This town planning report has been prepared on behalf of the Applicants, Kim & Joanne Moss, in support of a Development Application seeking a Development Permit - Material Change of Use for Low Impact Industry (Repair, Storage & Ancillary Office) on land at 136 Crossland Road, Gordonvale, formally described as Lot 2 on RP747646. The site is located within the Rural Use Precinct of the Cairns South State Development Area.

Material Change of Use for Low Impact Industry (Repair, Storage & Ancillary Office)

Information Request Response
Development Application for Low Impact Industry
136 Crossland Road, Gordonvale – Lot 2 on RP747646

Figure 1: Site plan containing nominated activity locations. Source: Brazier Motti

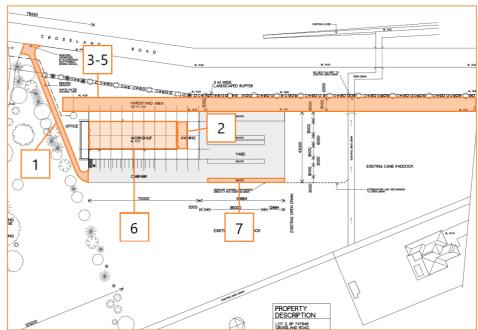
2. The SDA application material does not provide a clear description of the process required for the repair and maintenance of the marine nets, the interrelationship between each stage of onside operations nor does it describe movement throughout the site.

The process of onsite operations is relatively straightforward. *Figure 1* shows a site plan with the order and location of onsite operations labelled. *Figures 2 through 8* and associated descriptions provide the method in which nets are delivered, washed down, cleaned, dried, repaired and stored.
